DATE: November 7, 2005

RE: Call for Review of Tentative Parcel Map #061676 and Hillside Development Permit #4395 for 720 South San Rafael Avenue (725 Hillside Terrace).

Revised Recommendation

Attachment C
Landscape Plan Showing Tree Canopies

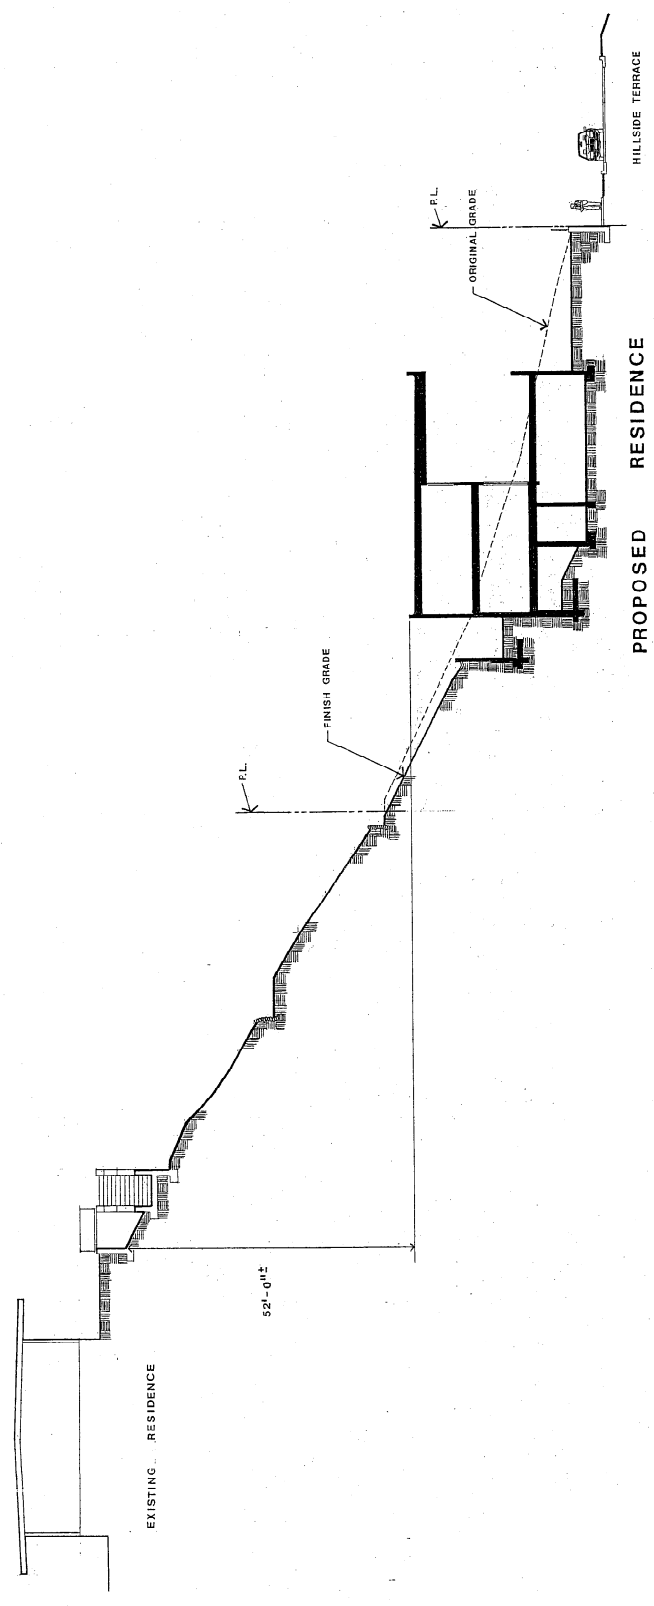
Some of the meeting attendees were concerned that the eleven trees to be planted between the house and the front property line would be inadequate to properly screen the house from the street (Hillside Terrace). In response to this, the architect has submitted a revised landscape plan (Attachment C) that shows the existing and proposed tree canopies. This plan shows a high amount of tree foliage throughout the property, particularly between the house and the Hillside Terrace.
